SIB 51 33 16

2021-06-01

SLOSHING NOISES/WATER IN REAR PASSENGER COMPARTMENT

This Service Information Bulletin (Revision 2) replaces SI B51 33 16 **dated July 2019**.

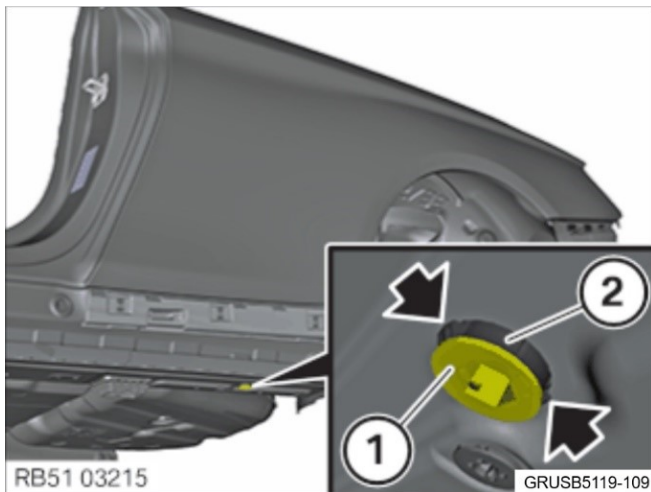
Poor water drainage due to installation location of the rocker panel trim.

Remove the drain outlet.

Remove the underbody paneling to access the water drain outlet shown to the left. Refer to repair instructions **51 71 017 "Removing and installing/replacing (left or right) underbody panelling"**.

Completely remove the drain and do not reinstall. Clean any residual debris from the underbody panelling.
